**Reference Planning Application No. 2016/2457/P**

Our Ref: P164917

**Planning Application 2016/2457/P**  
**'Demolition of existing buildings and erection of new buildings to provide replacement funeral directory facility at ground and basement levels of 4-8 Ferdinand Place. Provision of nineteen Class C3 residential units (5x 1 bed, 8 x 2 bed and 6 x 3 bed units), split across eight units provided at first, second and third floor levels at 4-8 Ferdinand Place and eleven units at ground to fourth floor level at 1-3 Ferdinand Street' at 1-3 and 4, 6, and 8 Ferdinand Place, London**

Diagram A Possible Cause Area Effect

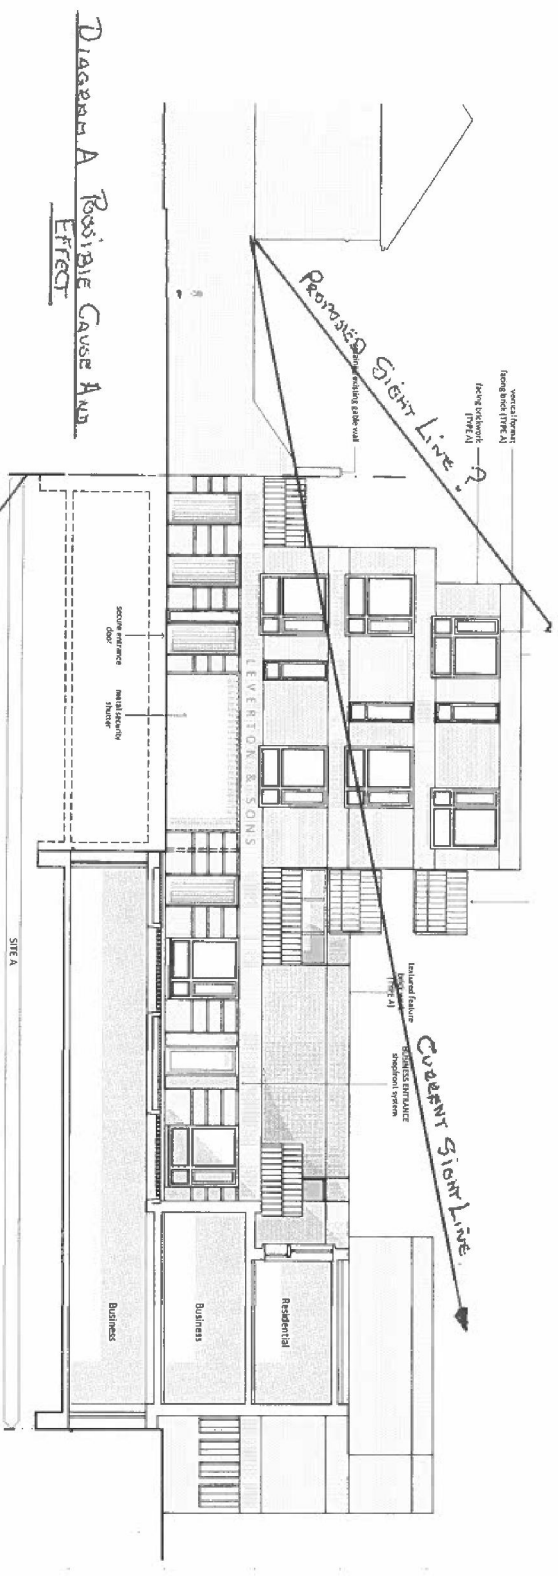
We are also very concerned that neighbours who attended the same consultation as ourselves seem to have been told different things and that the plans as shown do not correspond with either, and at times conflict with other bits of the written proposals/artwork on the submitted planning drawings and details, which also do not appear to be to scale or have measurements readily available, this is both confusing and very worrying as we cannot make realistic comparisons with the plans proposed. These two developments would cause us to be overlooked from a few metres away with the resulting loss of privacy, sunlight and daylight to all 3 floors of our windows, and garden, especially as the sun travels from Harmood Street and around to Ferdinand Street on plan in an East - South to West direction. The building proposed obscuring the suns path to our property as it travels around. See attached diagram A

Proposed section extract showing the significant additional bulk proposed by the replacement buildings on Site A and Site B and so loss of outlook and 'sky' above the buildings.

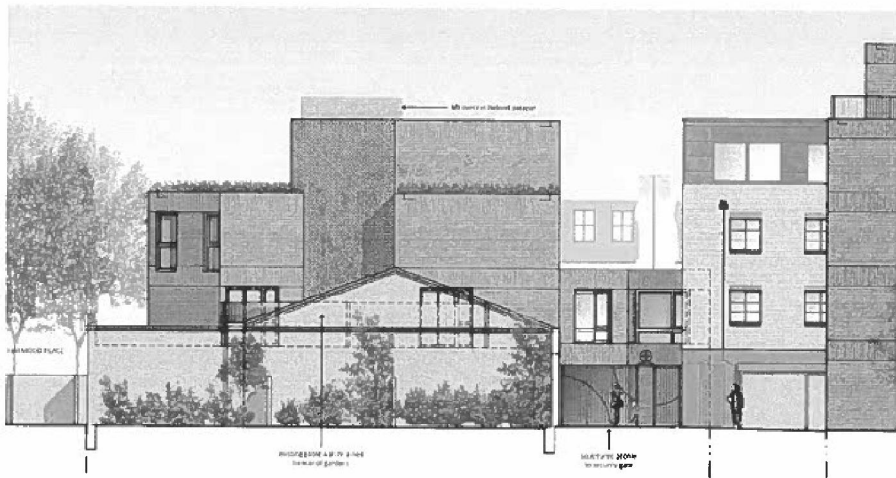
As demonstrated above the existing building at Site A is single storey, and this will be replaced with a much taller 4 storey building. Although the design proposes stepping the highest parts of the building back away from Collard Place, it remains extremely close with the first and second floors set back only approximately 2.75 metres from the shared boundary and the fourth floor approximately 4 metres back. (The first floor balcony privacy screen will be approximately 0.2-0.25 metres from the boundary).

The proximity and height of the proposed building, coupled with the blank appearance of the elevation facing the rear of 4-6 Collard Place would result in an extremely oppressive and overbearing impact and a clear sense of enclosure being created.

Further the proposed new building on site B would be five storeys (replacing a two storey building) and would only stand 12 metres away to the west of 4-6 Collard Place and their rear gardens. Again an oppressive and overbearing impact is created.

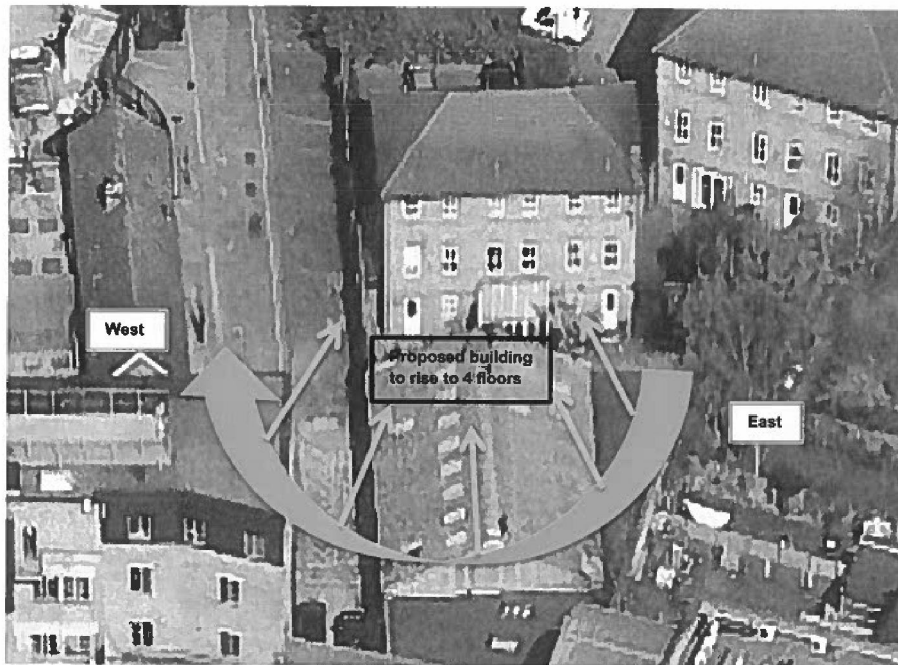
As will be noted, this identifies that the level of daylight 4-6 Collard Place receives is exceptionally high for an urban location (Vertical Sky Components-close to 40%), however following the erection of the proposals, the levels of daylight would be less than the BRE recommendation (VSC 27%).

It is suggested that these would be considered adequate for an urban environment, and that it is unlikely that occupants would notice a loss of light to windows.

This is a wholly illogical conclusion to draw i.e. levels of light are currently good, and these would drop below BRE standards but none the less it is suggested that the properties owners would not be impacted.

This is simply incorrect and it is clear that the applicants own report demonstrates that a harmful reduction in daylight would result from this development for the reasons discussed above (additional height and bulk in such proximity to the rear of Nos 4 – 6). This is contrary to Council policy.

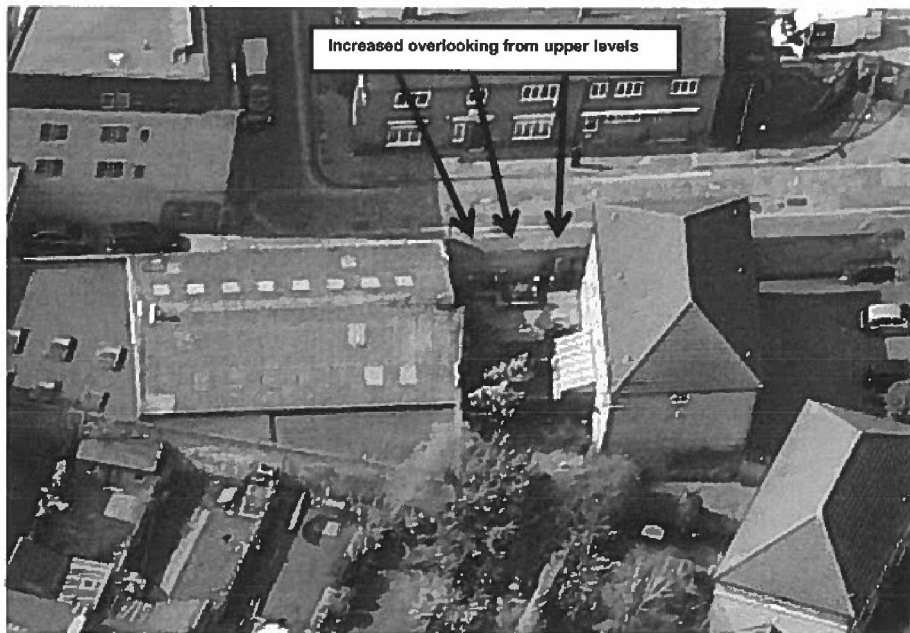
As noted above, the first floor balcony of the proposed Site A building would be just 0.2-0.25 metres away from the shared boundary with Collard Place, whilst the distance between the proposed first floor glazed doors and the rear elevation of 4-6 Collard Place is just 11 metres.

Although the balcony is to accommodate a 1.8 metre high privacy screen, the close proximity of the balcony and glazed doors to Collard Place would reduce the level of privacy afforded to the existing properties. This is particularly clear, given the recommended privacy distance set out in Camden Planning Guidance 6 of 18 metres between habitable rooms. It is understood that when the applicants carried out consultation with local residents it was suggested that there would be no general access to this area.

This is not however annotated on the plans which suggest access would be possible. A condition ensuring the area could not be used as a terrace would be required.
